CONSTRUCTION DOCUMENTS FOR:
HAVEN VALLEY
 (LETA DR.) BRADLEY RD/ALTURAS DR.
 SECURITY, EL PASO COUNTY, COLORADO

v1_Construction Drawings.pdf Markup Summary 10-19-2023

HAVENLOCK POINT
 PLAN & PROFILE

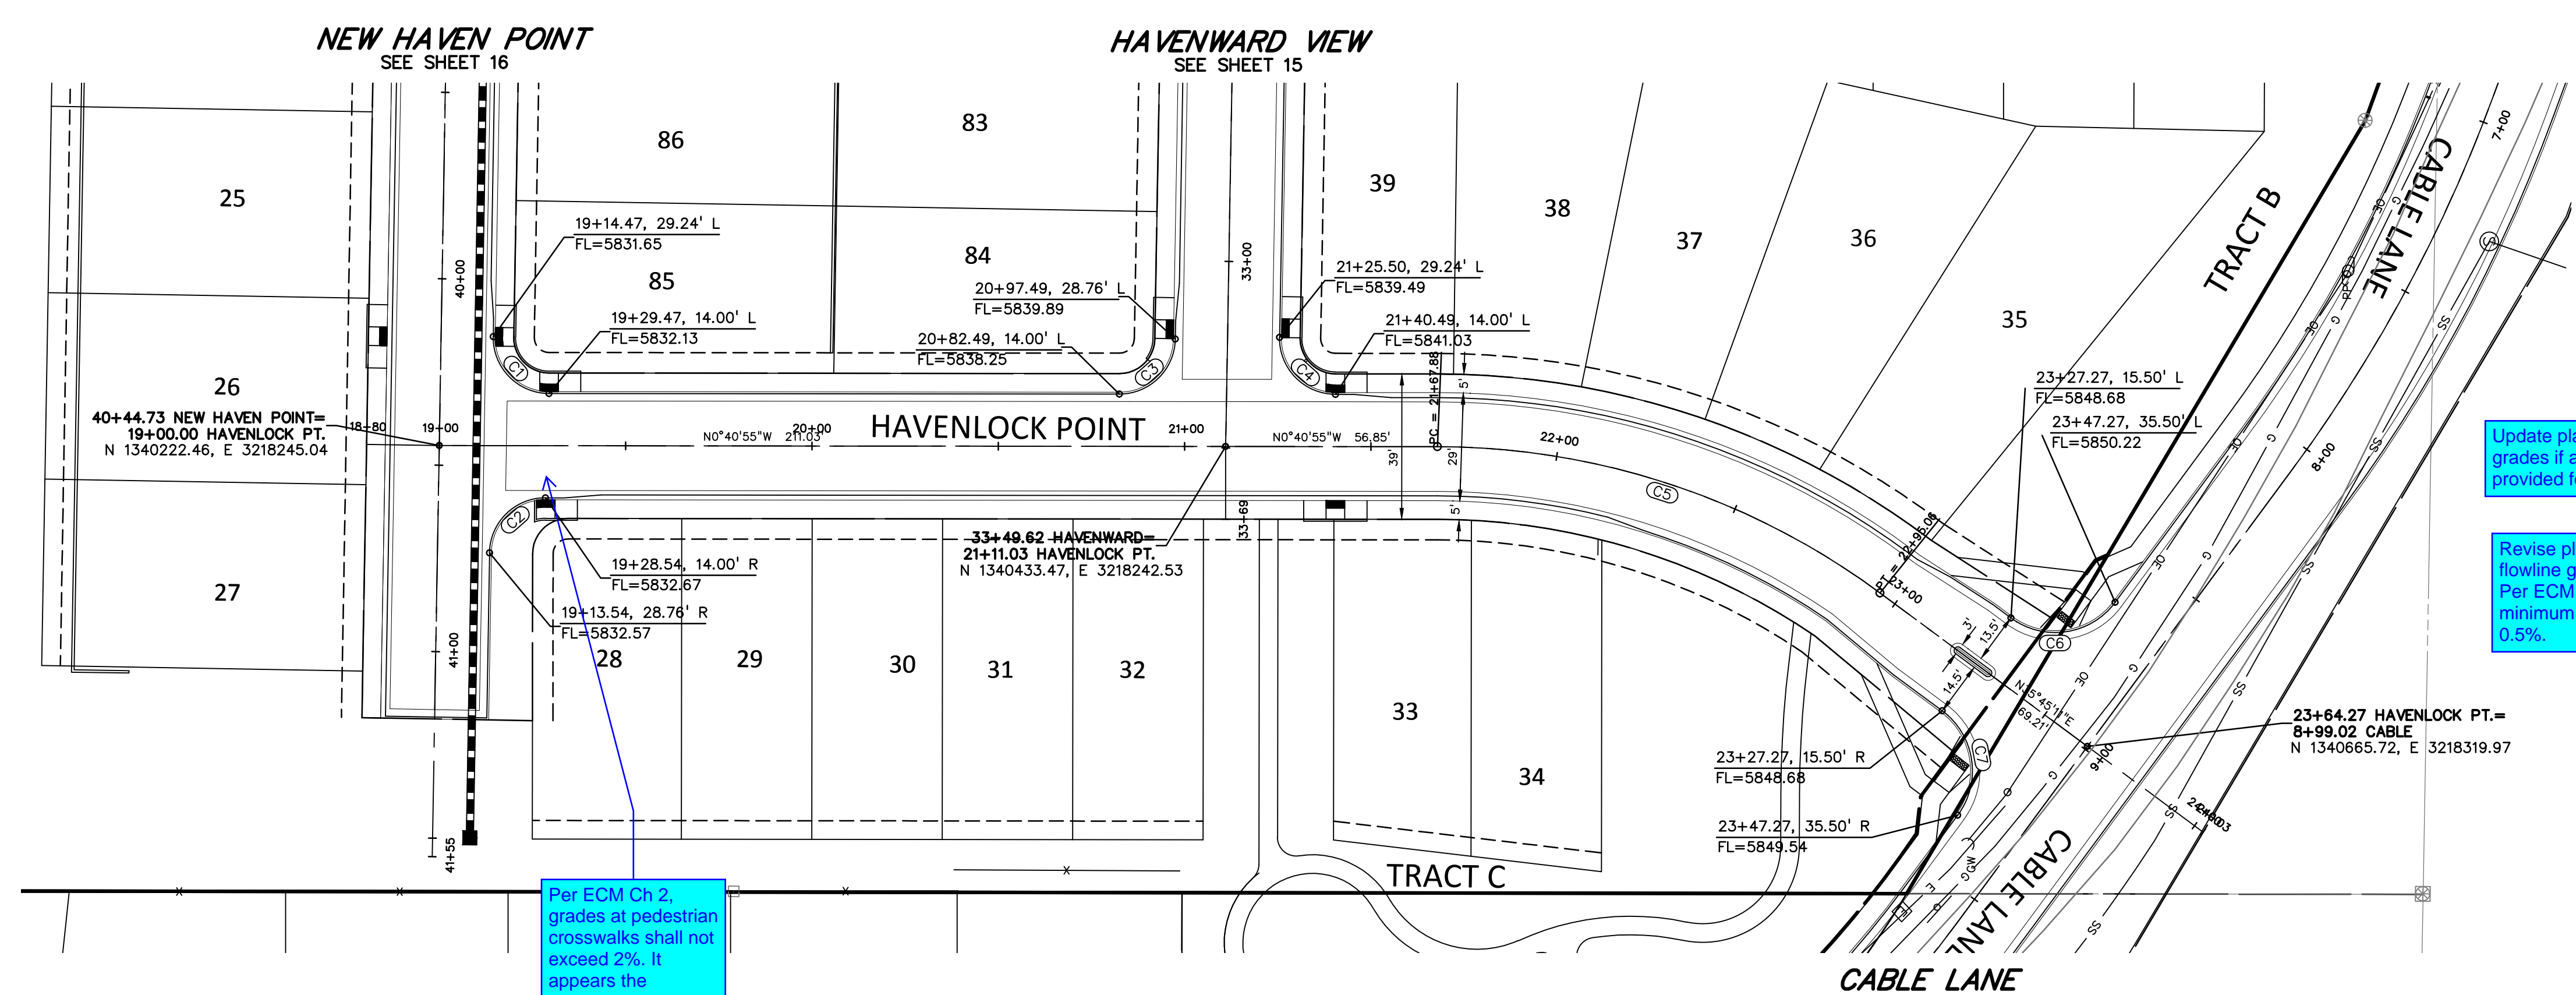
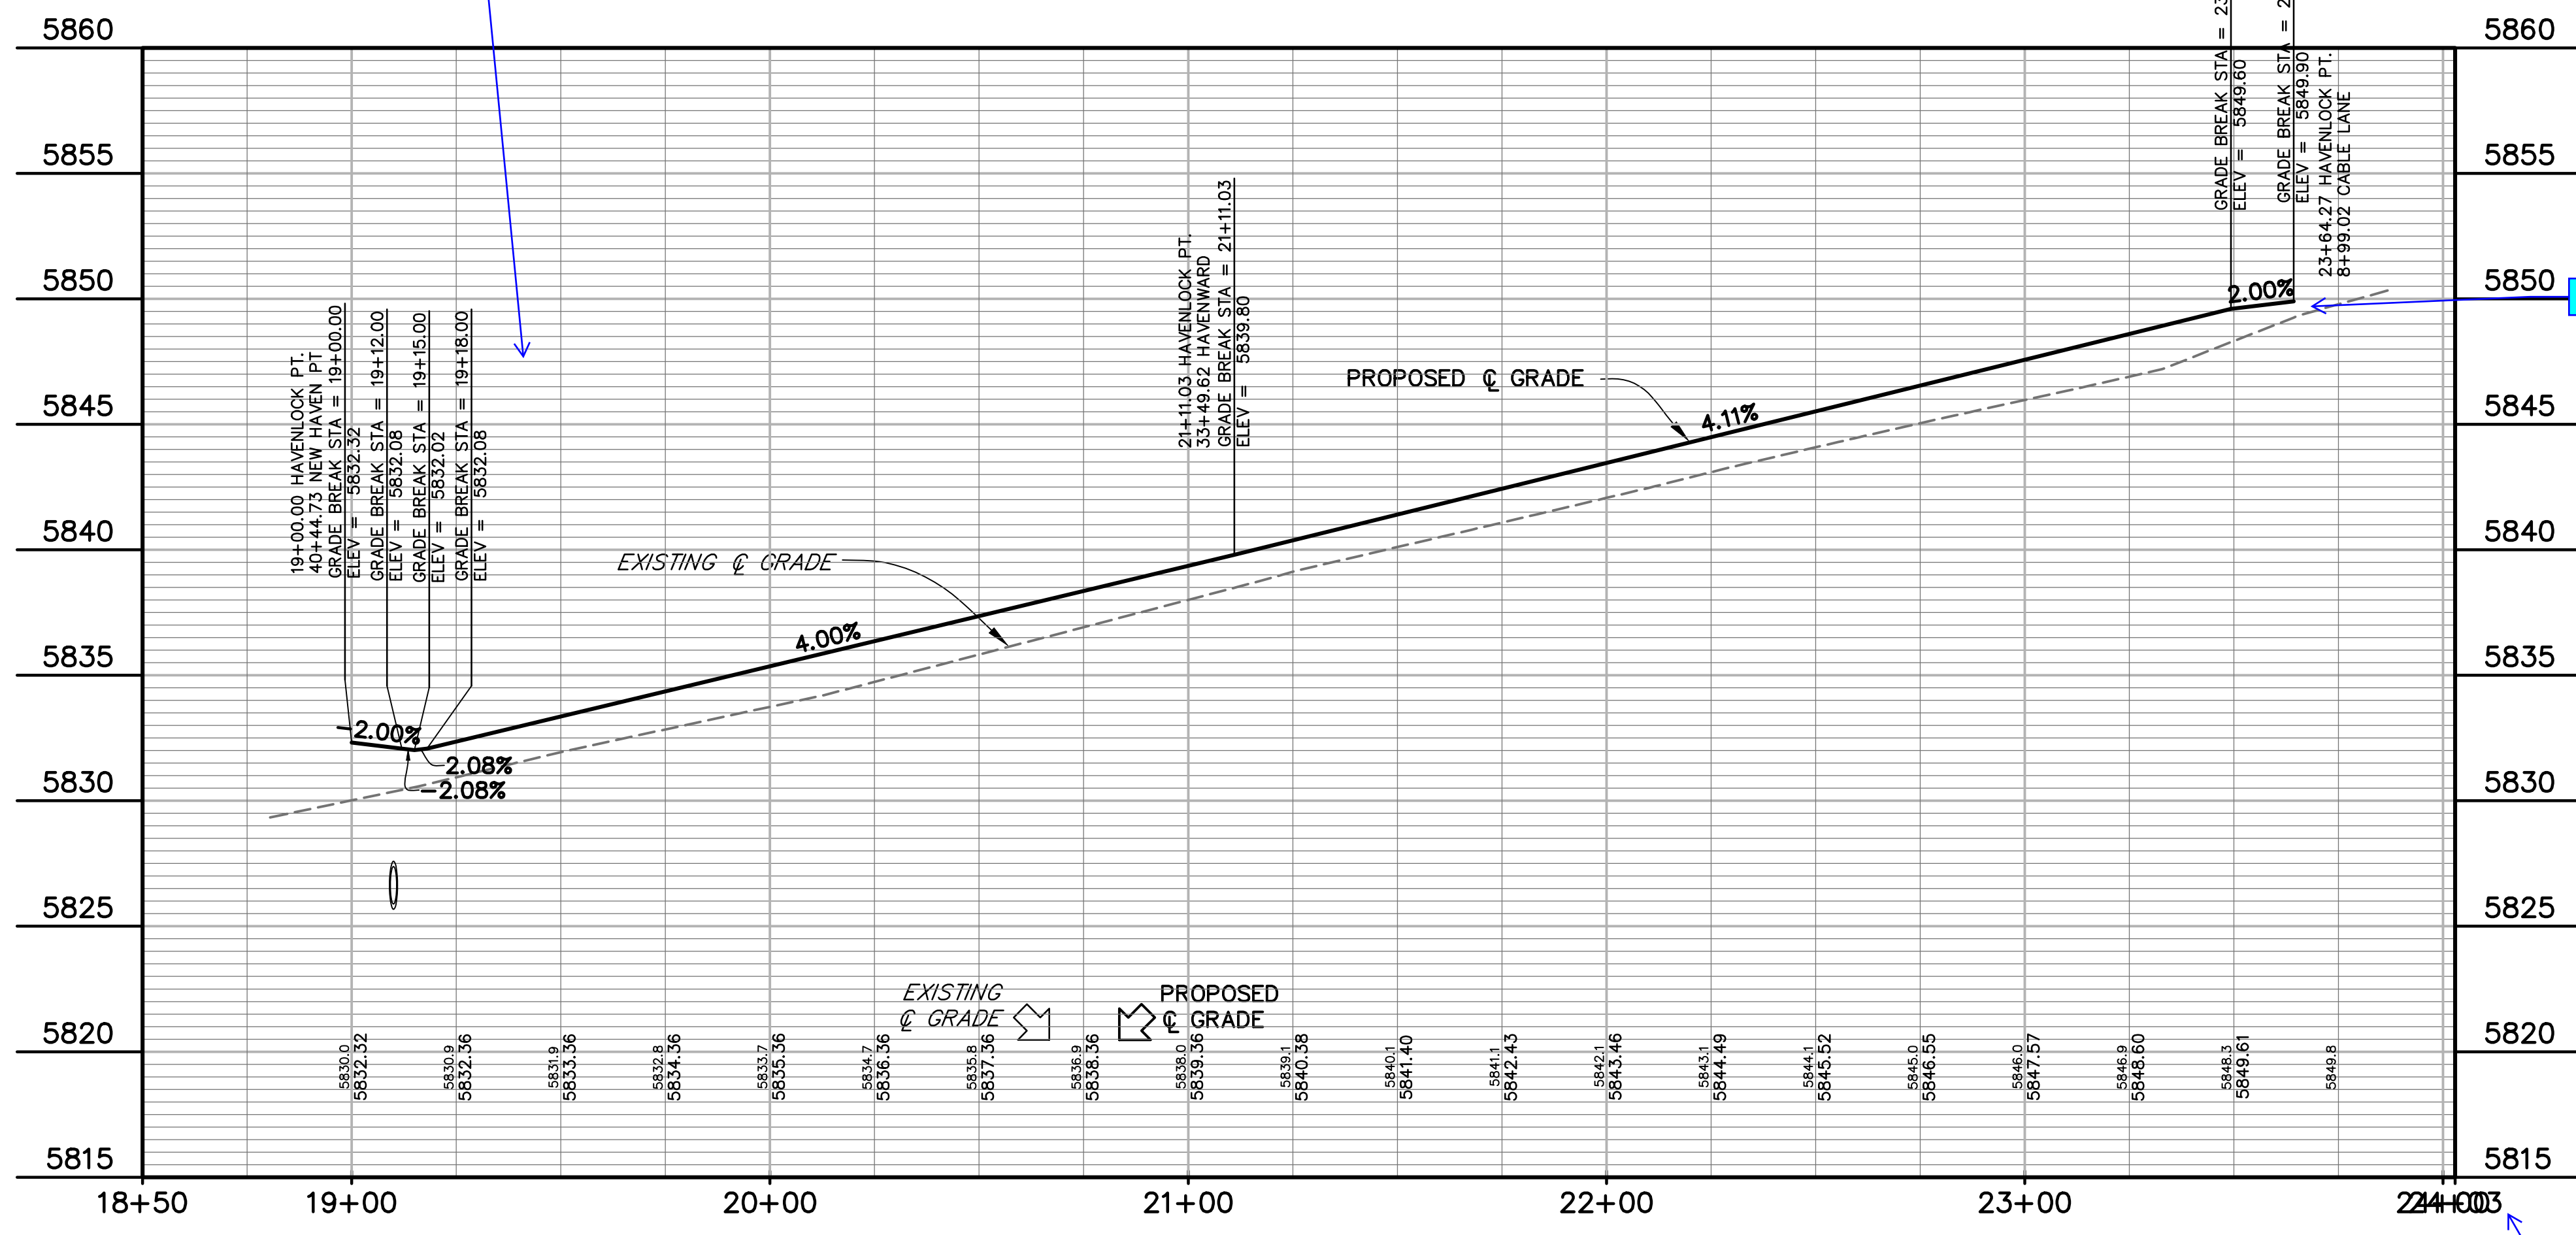
Update plans to show pedestrian ramp grades if a separate sheet will not be provided for this.

Revise plans to show flowline grade of curb. Per ECM Ch 2 minimum grade is 0.5%.

Per ECM Ch 2, grades at pedestrian crosswalks shall not exceed 2%. It appears the crosswalk will be located before the 2%. Revise.

Show tie in.

LATERALS
STORM SEWER
PLAN & PROFILE
PROJECT NO. 21085-03CSCV
DRAWING NO.

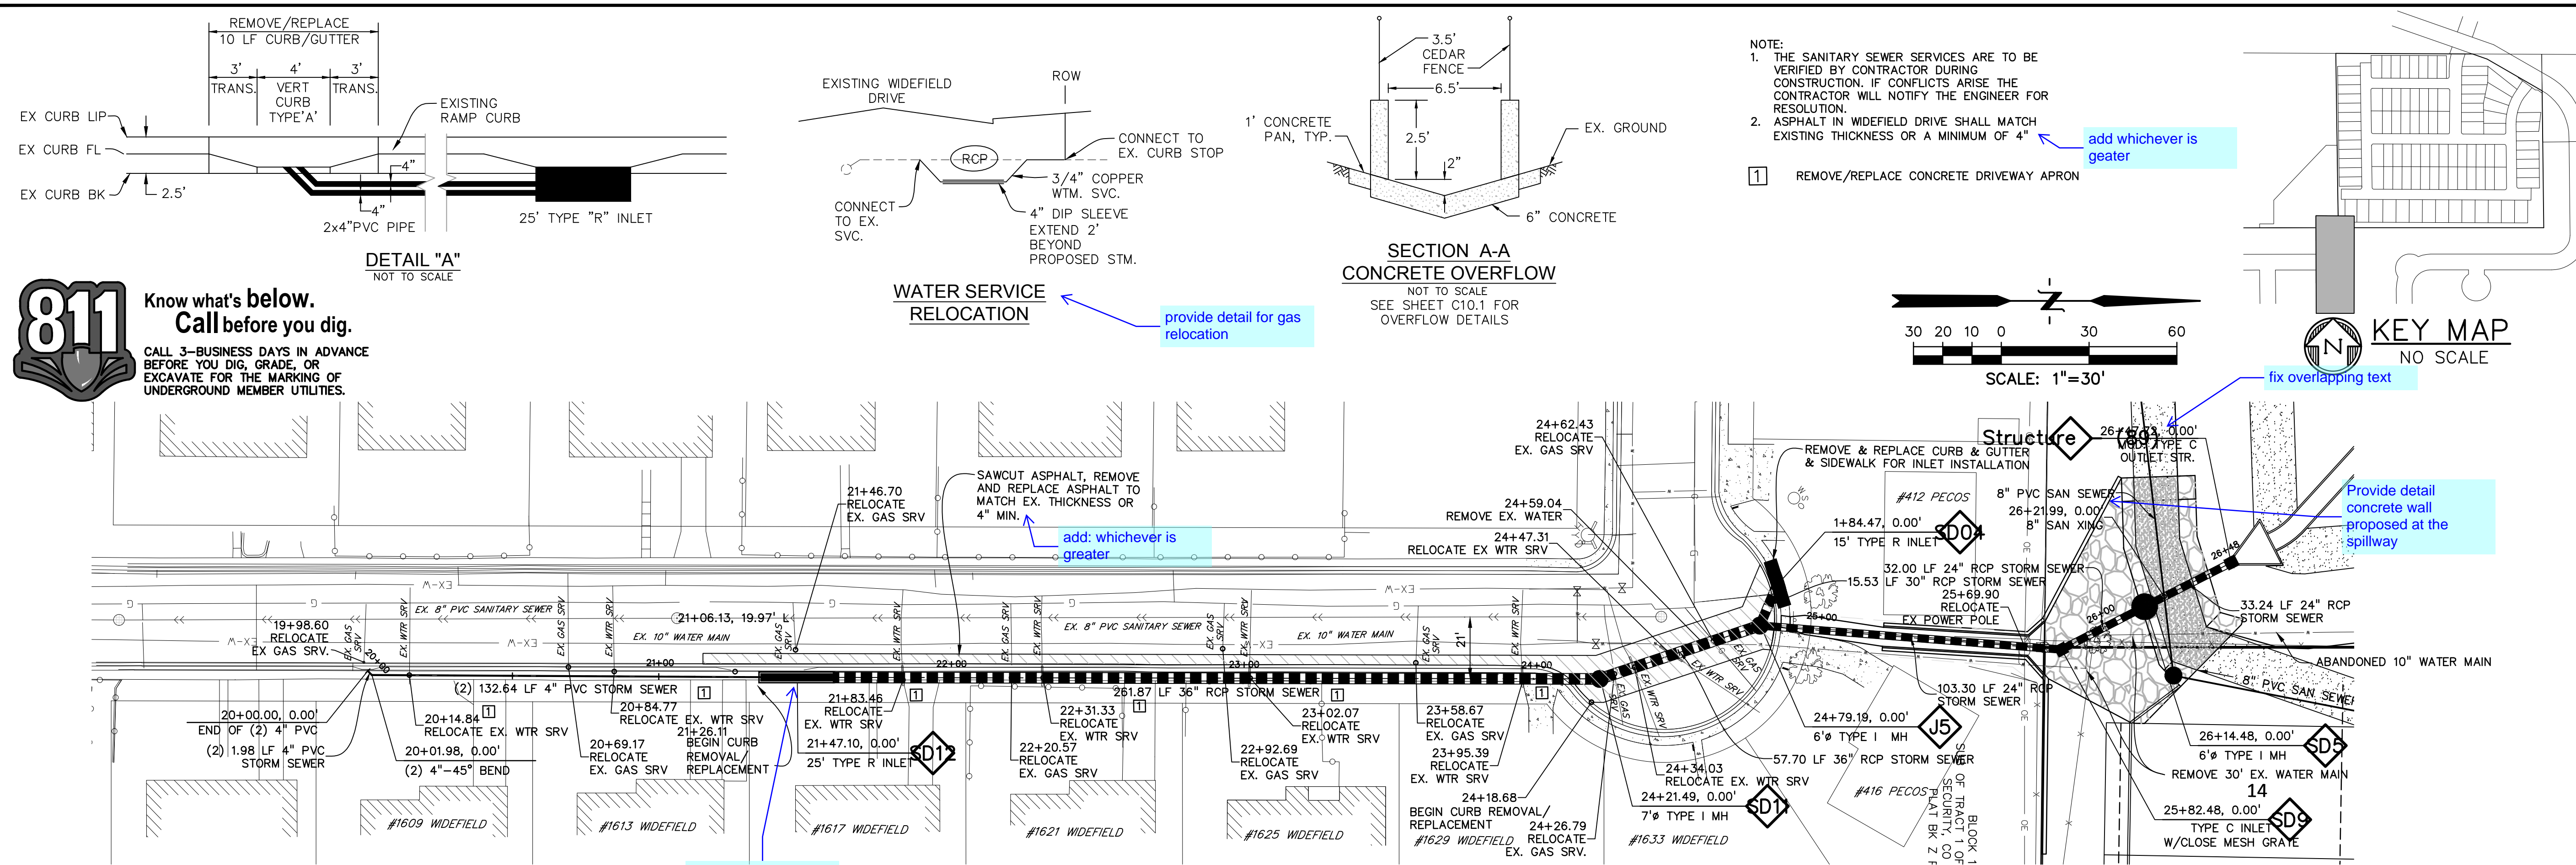
Update FAE to include all storm improvements in section 3.
Public improvements shall be in section 2
